Access Compliance Report

Public Rights-of-Way

(Curb Ramps)

Intersection ID: 16392	Main Street: QUEENS_RD_WEST	Cross Street: WELLESLEY_AV	Location: S
ADA ID: B86C1119BFED	Ramp Type: MedianPerp	Initial Pass/Fail: Fail	Overall Compliance: No
		Severity Score: 12.5

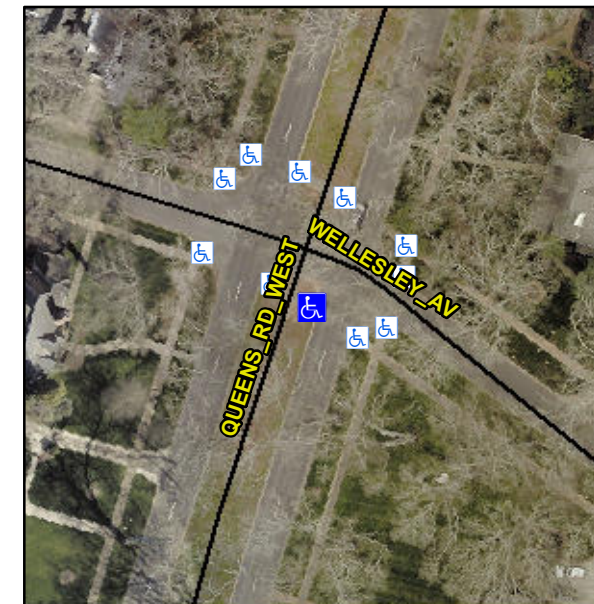
Not Found, R304.2.2

Remove & Replace Entire Ramp.
